Project Title: Siu Ho Wan Station and Siu Ho Wan Depot Replanning Works

(Application No. EIA-253/2017)

Submission of Information Pursuant to Section 8(1) of the EIAO

Figure 2 – NLH Road Realignment for Station at Central Location

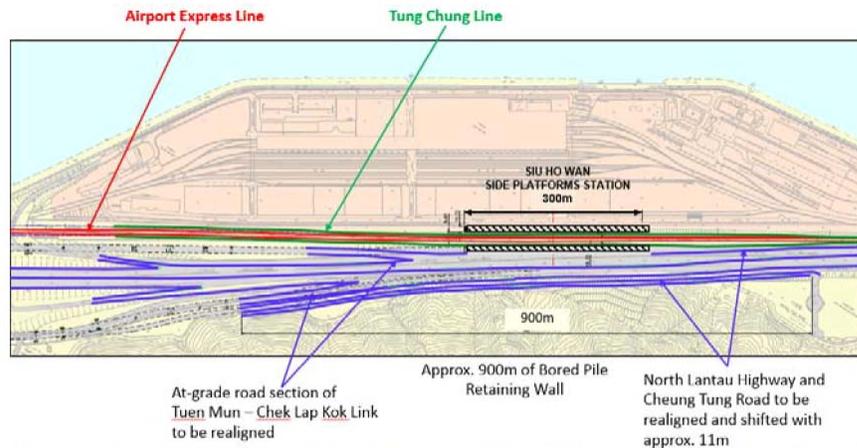
(e) Information on further elaboration and clarification of the considerations given to choose the Western Station Option instead of the Central Station Option.

- Because of the existing track configuration, the southern side platform of the central station option will encroach into existing North Lantau Highway (NLH). As indicated in **Figure 2 & 3**, permanent NLH road realignment, extending to the ramp of Tuen Mun Chek Lap Kok Link Road, will be required. Key issue arising from this realignment is that it will need to cut into the existing slope adjoining to the southern side of NLH. Slope works required for the realigned NLH would create a Natural Terrain Hazard to a large extent of the hillslope at the vicinity and may extend beyond the Country Park boundary (i.e. Lantau North (Extension))

Country Park). Moreover, the realignment works at affected area and the potential natural terrain improvement works will also encroach into Tai Ho Priority Site (indicative works area is approximate 1ha) and may impact directly on both existing vegetation and natural habitats.

- Furthermore, relatively higher construction dust, noise, waste and water quality impacts is anticipated from the construction works involved which would also result in higher indirect impact to the Tai Ho Priority Site. In view of this, this station option is not preferred from environmental point of view.

Based on the above factors considered, Western Station is recommended.
